ERM/NATS-IAA IRISH SEA ACP Pt2

CAA DECISION LETTER

PROPOSED INTRODUCTION OF REVISED L975, L70 AND L10 ROUTE STRUCTURE WEST OF WALLASEY

Revised L975/L70/L10 and LYNAS RVC

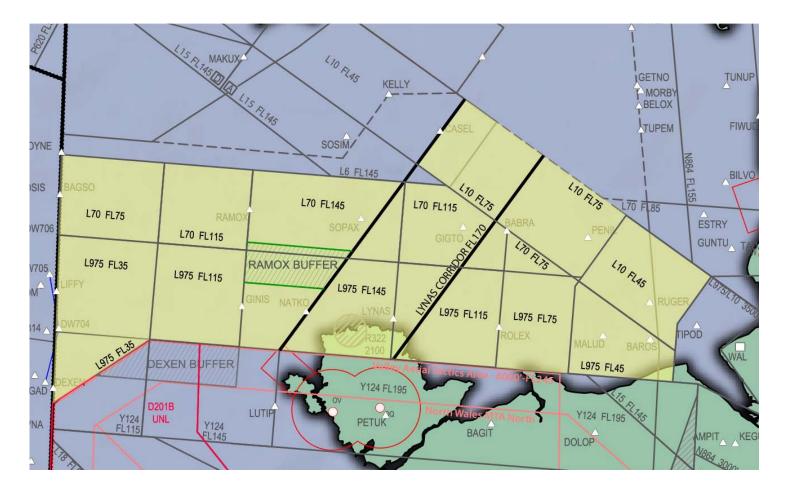
- 3.2 The results of NATS' consultation enabled it to identify areas of CAS that could be removed. L10 will be raised from FL65 to FL75 between PENIL and CASEL, providing an increased 1000ft of Class G uncontrolled airspace. L10 and L975 will be raised from 3500 feet to FL 45 west of Wallasey, again providing increased Class G uncontrolled airspace. This airspace was established for use by arrivals to and departures from Liverpool John Lennon airport. Analysis showed that it was rarely used at these levels and NATS declared that it was therefore no longer required.

- 3.3 The MoD is satisfied that the RAF Valley operational requirements are in the main accommodated by the new LYNAS corridor (RVC) from Designated Base (DB) to FL170 through L975/L70 and FL170 through L15/L10). However, due to the lack of solid primary radar cover, certain parts of the corridor will require aircraft to receive a procedural clearance to allow climb into, transit through, or descent out of, CAS.

- 8.2 I have therefore decided to approve the revised ATS route structure to accommodate better descent profiles into Dublin and to simplify the existing complexity of existing base levels. The revised airspace will become effective from 13 December 2012. My staff will review the effectiveness of the arrangements not before 12 months after introduction and the results of this review will be published.
